COTTAGE CLUSTER

L1

RAISED CENTER COURTYARD

MIXED UNIT CONDOMINIUM

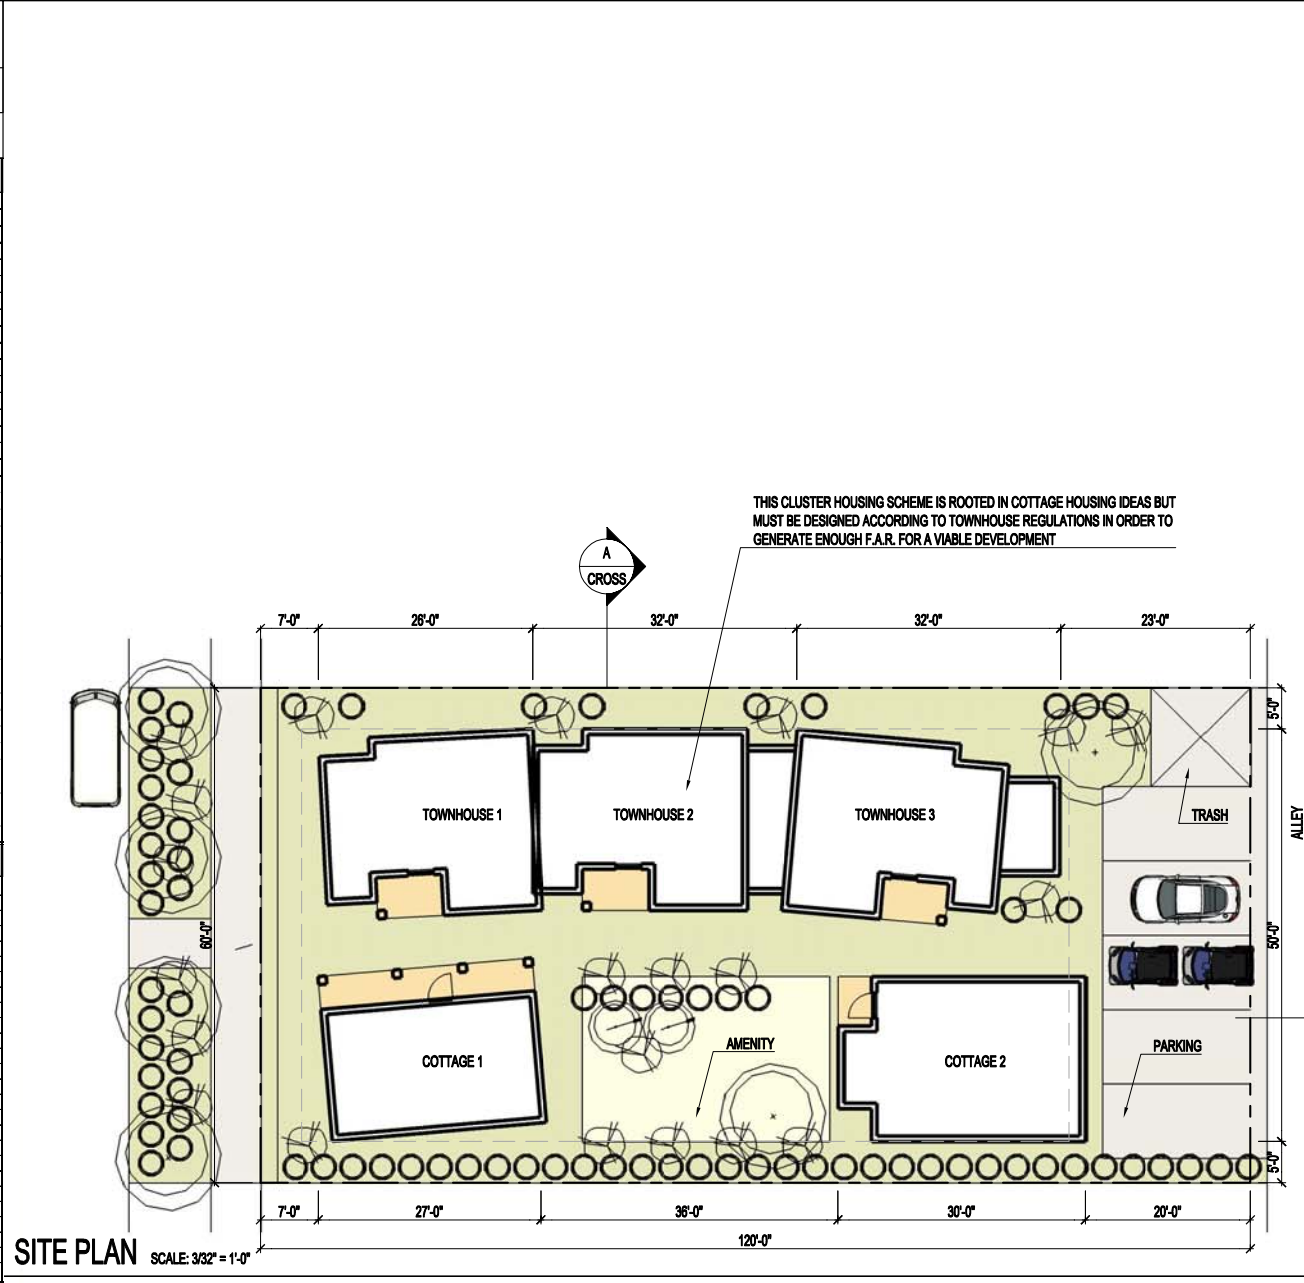
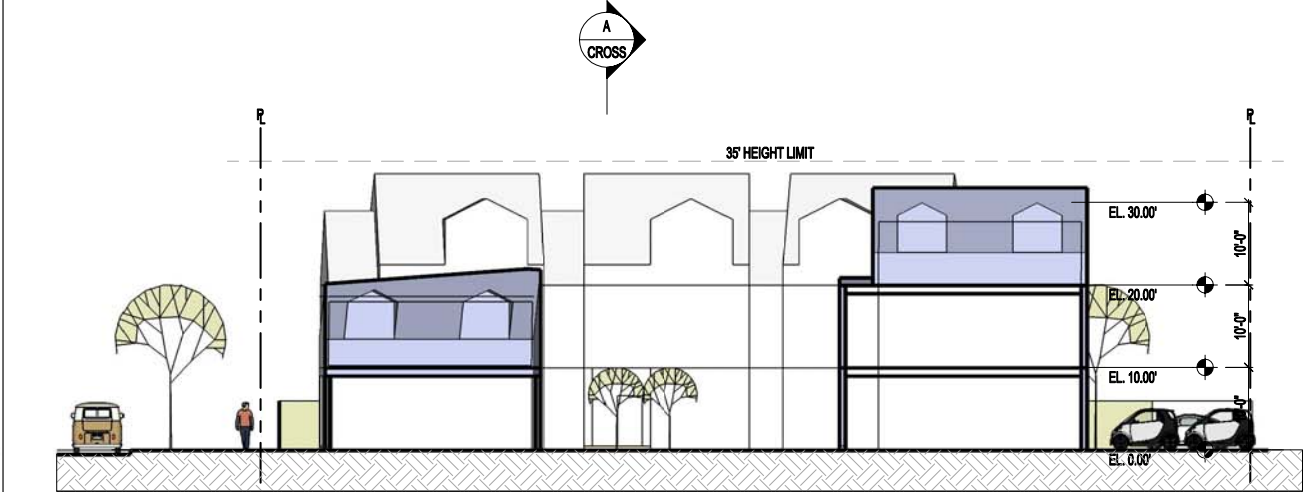
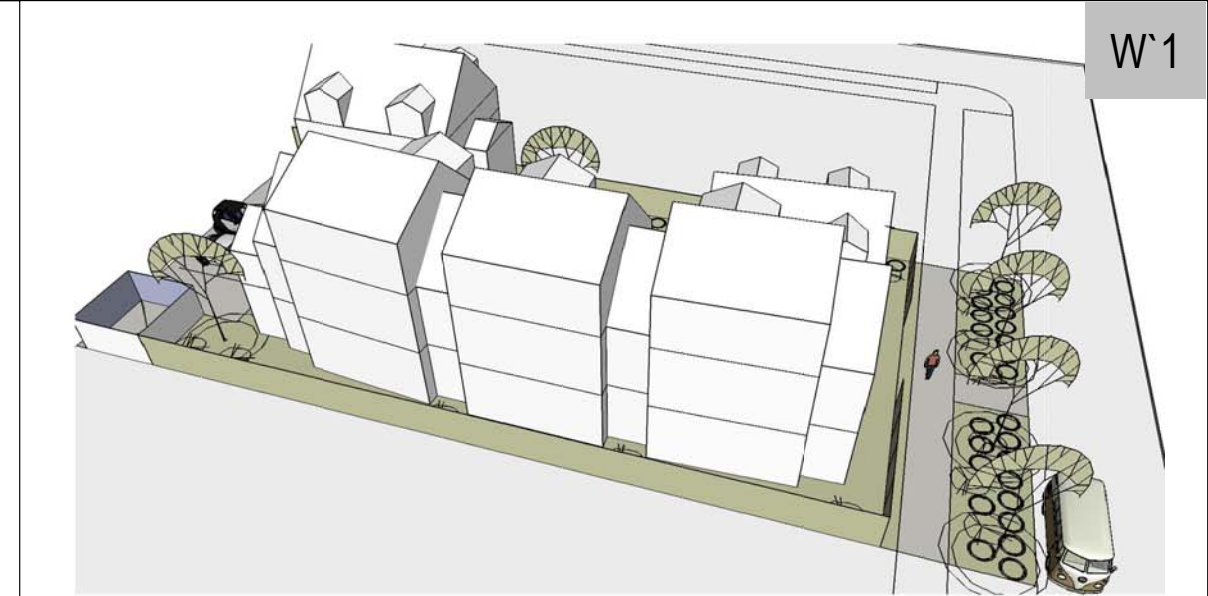
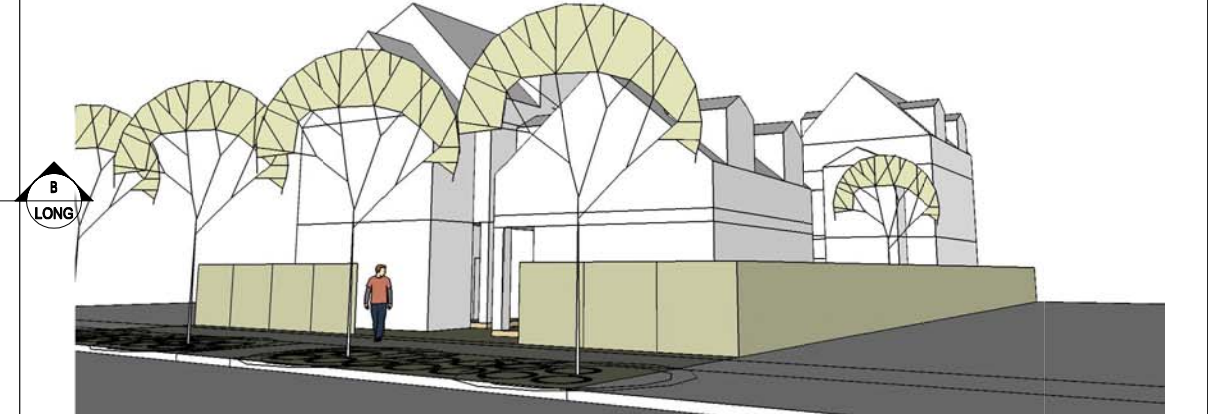
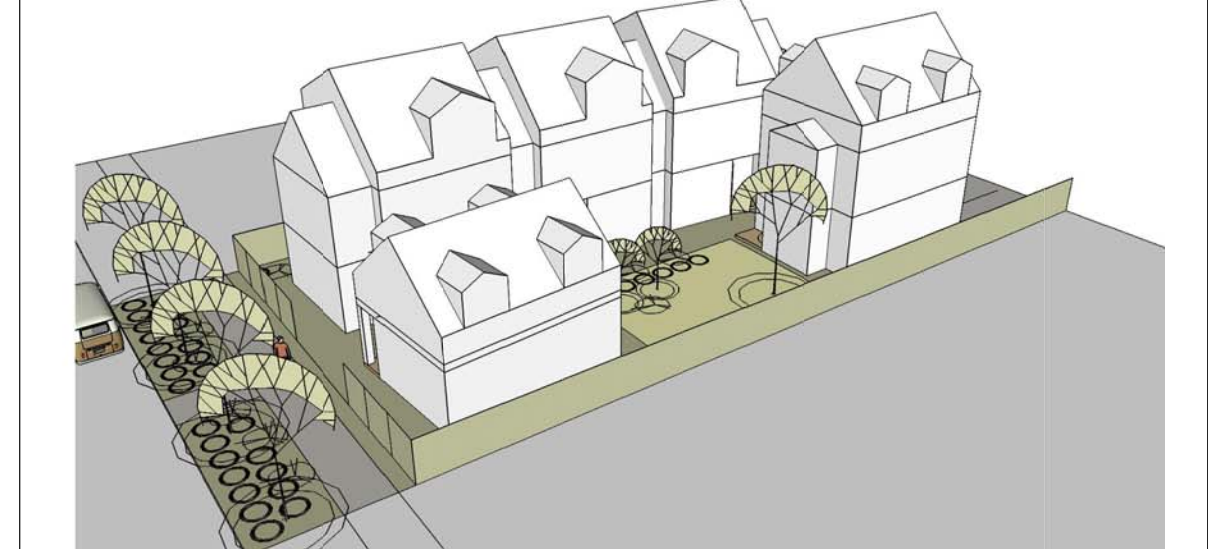
- This scheme mixes elements of the cottage standards with multifamily townhouse standards.
- Common open space in lieu of private provides far better amenity and community space.
- Alley access is essential, otherwise the parking and vehicle circulation eats up too much site area.

- FAR is self limiting and can only approach 1.0 at best. The scheme would probably not pencil on an L3 lot.
- The scheme will not work well on lots less than 60' wide. It would work very well on larger lots or as a mirrored scheme on double lots
- L1 density limit holds the scheme to 5 units and drives a developer to provide larger units rather than a variety of sizes. Increasing that limit would allow for more housing choices in this scheme.
- This scheme was originally explored according to the cottage housing guidelines. However, cottage housing was too restrictive and the idea had to be transformed into townhouses in order to get enough FAR to make the scheme viable.

- Cost to build would be moderate to high. Free standing structures are inefficient compared to attached.
- Ability to adapt easily to sloping sites could help reduce cost of excavation and soil import/ export in some cases

- This scheme is intended to illustrate how a good cluster housing scheme combines freestanding and attached buildings to generate an interesting site plan and quality community space. It is a mix of site design ideas from the cottage housing section with buildings too large to qualify as cottages. The cottage housing regulations did not allow a viable project in terms of yield. Introducing taller, attached structures into the mix preserves more open space, generates a viable square footage yield and achieves many of the site design goals associated with cottage housing better than a pure cottage scheme.

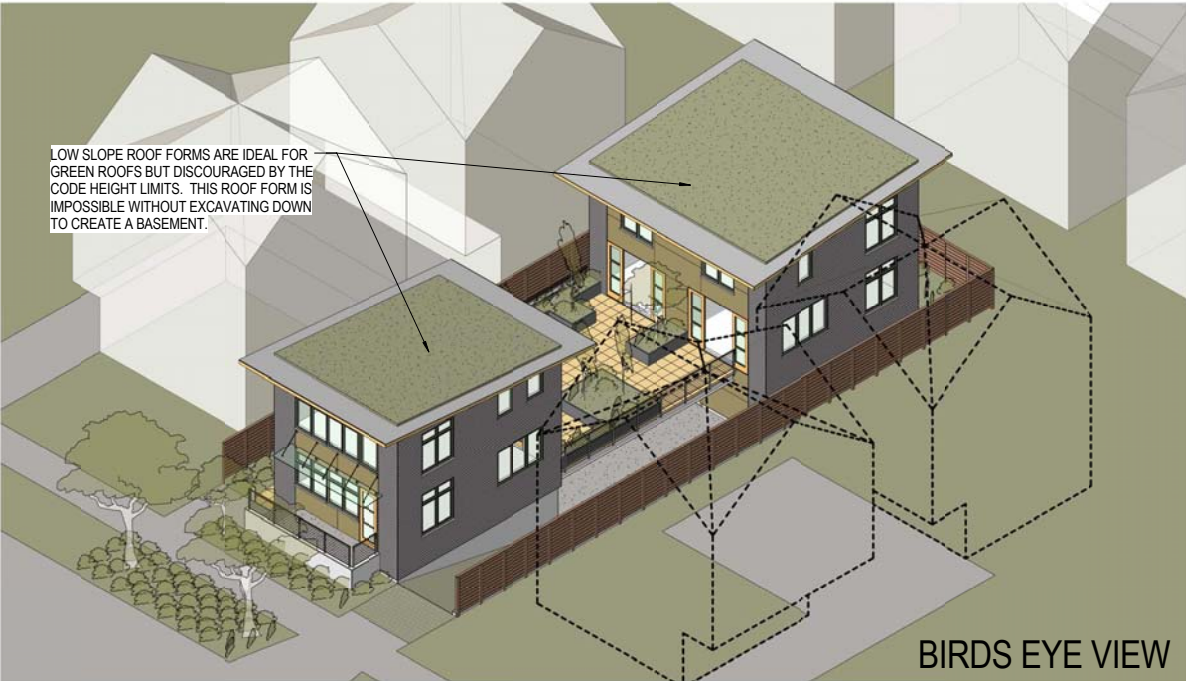
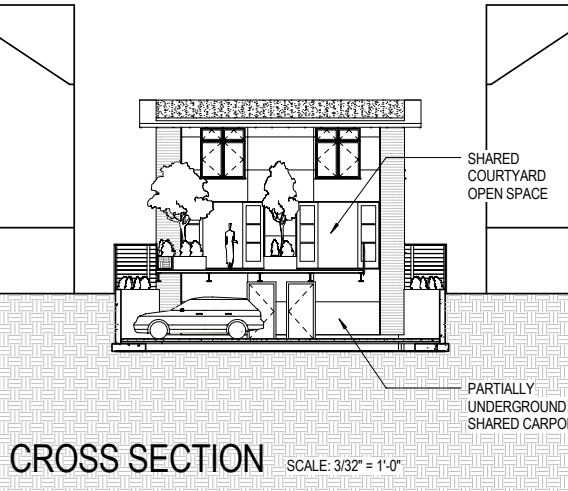
- Under current code, this scheme would require departures for: Front & Rear setbacks, Lot Coverage, Building Depth, and Open Space.
- The height exception for sub-grade parking is very helpful. This scheme would have height limit problems without it.

- The scheme is a bit self limiting. In order to avoid the cost associated with true structured parking, the housing isn't built over the parking area. Once the necessary area has been allotted for parking, there's only so much area left over for buildings. Once that area has been filled out & built to three stories this scheme tops out at an FAR of about 1.1.

- The primary cost factor in this scheme is the recessed parking and the construction of the lid itself. However, since no FAR is used for parking, there is also a financial benefit.
- The extent of green roof is driven by green factor. It would be a very costly element.
- Using interior square footage for waste bin storage is a significant loss of saleable area.

- FAR exemptions must be clarified to exempt all open space lids on top of parking. Otherwise, schemes like this will be penalized if they are built on downhill sites.
- Green Factor, as currently proposed, doesn't incentivize design choices that are appropriate for housing. Expensive, significant amenities like permeable paving and green roofs are meagerly rewarded, while heavy shrub landscaping & vegetated walls are highly encouraged.
- Area required for waste bin storage is excessive & inflexible. The required dimensions are incompatible with parking dimensions & side setback areas. Many developers will choose to simply place them in the front yard.
- Setback averaging penalizes this scheme. With a 5' side setback, this project could meet the 1.1 FAR allowed by the zone.

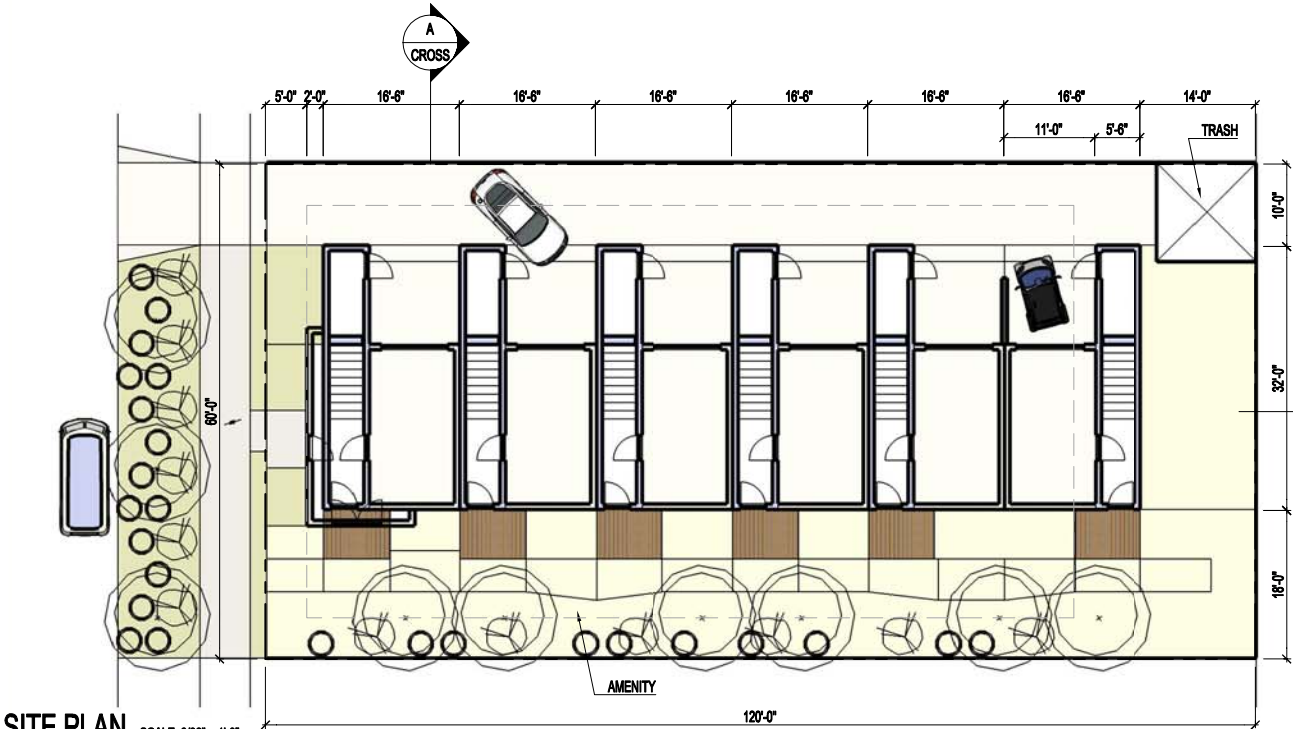
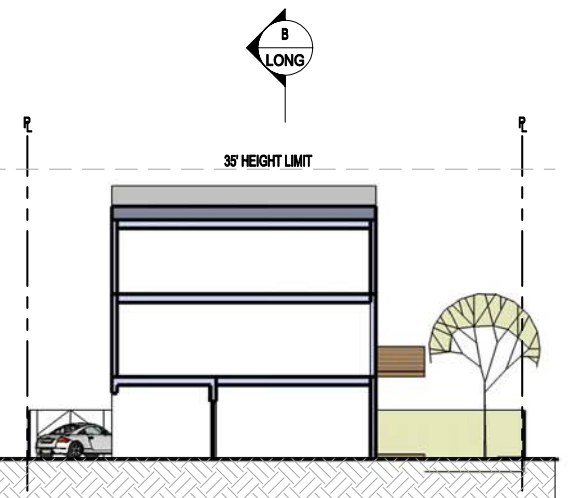
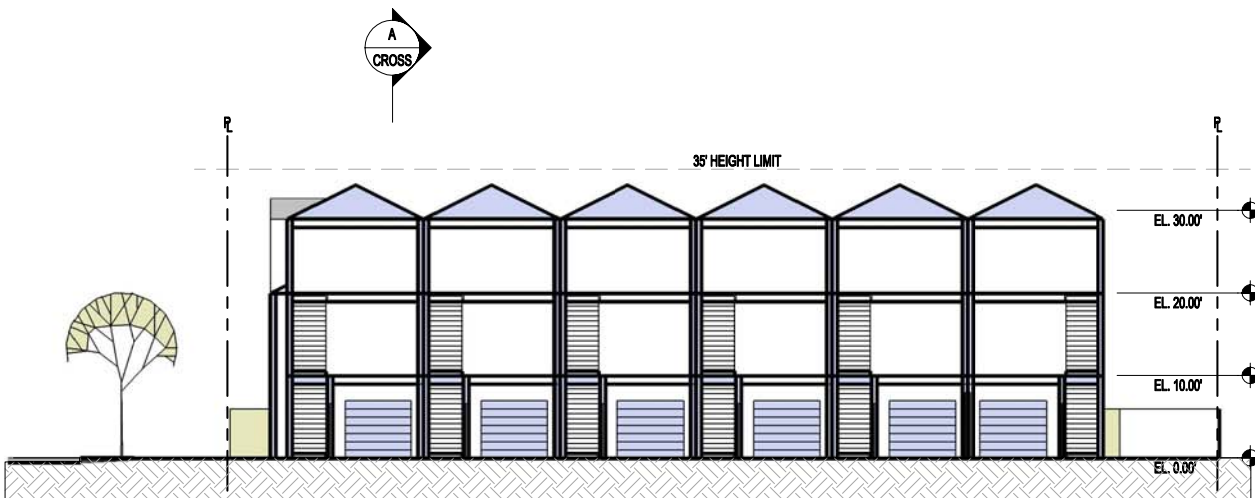
- ENABLING FACTORS:
- On a sloping lot the FAR exception for sub grade parking could benefit this scheme
 - Common open space in lieu of private provides far better amenity and community space.

- Lack of articulation requirements at side facing facades provides design flexibility
- GATING MECHANISMS:
- Backing space for parking erodes the first floor compromising unit relationship to the ground plane and reducing FAR

- The scheme will not work well on lots less than 60' wide. It would work very well as a mirrored scheme on double lots
 - Achievable FAR is limited without reducing the mews area to narrow corridor. In an L3 zone significant development potential would be left on the table or the scheme would be reduced to a black hat example with poor outside space.

- EVALUATION:
- Impact of Setback averaging unclear. Large open space oriented to the street should provide benefit against the facade area but there is no clear mechanism for this.

- At 1.15 FAR this scheme provides a generous pedestrian mews. If the townhouses were built out to 1.4 FAR the mews would be reduced to a narrow swath and would not likely achieve the goal of providing quality community space

- The scheme may actually benefit from a sloped lot which, if oriented advantageously, could bring the mews up to the living spaces while burying the driveway.

- Area required for waste bin storage is excessive & inflexible. Preferred location in rear yard is a poor choice for pick up services. Scheme works better with individual storage areas.

INFILL BEHIND EXISTING SF HOUSE

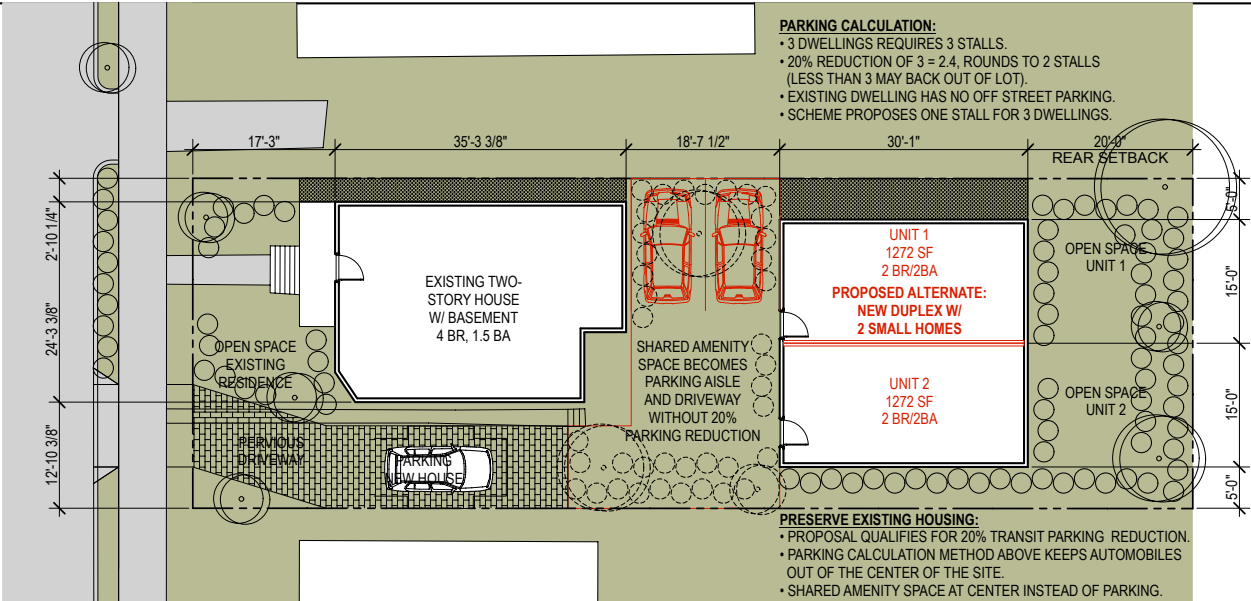
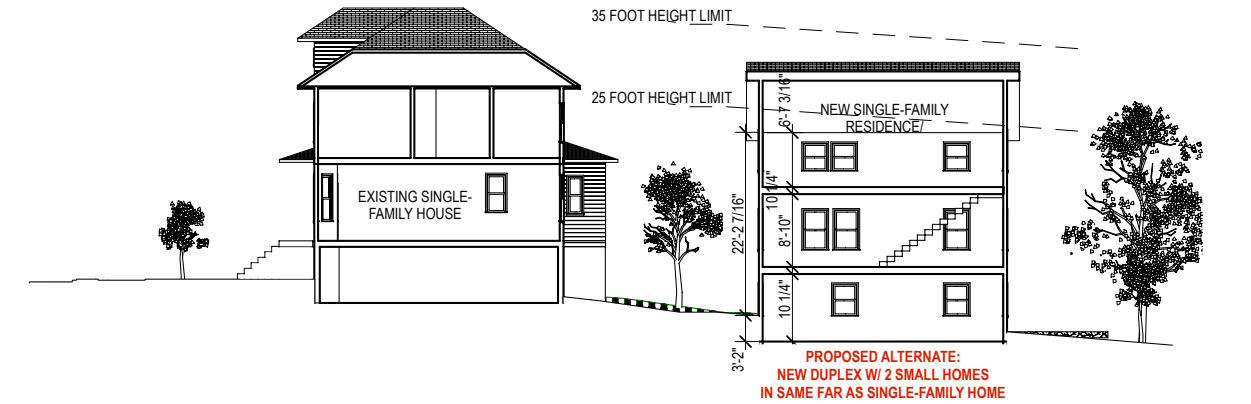
- ENABLING FACTORS:**
- This proposal is extremely similar to what can be done today under the current code. Why not be more bold?
 - Density limits remain in LDT, setbacks are the same as the current code because of the size of the new structure and the adjacency to single family to the rear of the development site.

- The alternate proposal suggests providing two smaller homes, thereby increasing the allowable density. The project saves an existing 1500 sq. ft. 1902 home recently remodeled and proposes providing only one off-street parking stall in either the code compliant proposal, since the existing home does not have parking, and the site qualifies for the 20% parking reduction. The two smaller homes, 1272 sq. ft. each, provide two affordable homes in place of the larger expensive one prescribed by the density limits in the current code. Perhaps Density can qualify for a departure through Design Review or projects that save an existing dwelling qualify for a Density Bonus.

- GATING MECHANISMS:**
- The scheme is limited by the Density limits still prescribed in LDT, L1 and L2 zones.

- EVALUATION:**
- The new legislation can be written to provide incentives to preserve existing housing stock, such as parking reductions and increased density potential. This additional flexibility will create affordable smaller homes.
 - Green Factor of 0.6 is difficult, even on a this site where parking and access occupies little ground space. The narrow planting strip contributes little to the overall Green Factor. Without providing green roofs or green walls, shrubs need to wrap all ground level open space, in excess of what is desirable.
 - Parking only one vehicle on site creates places for people. In the front of the existing house and behind the new structure are private open spaces, while the space between the two structures is a community amenity space. If more parking is required, that space is given over to a parking aisle and parking stalls.
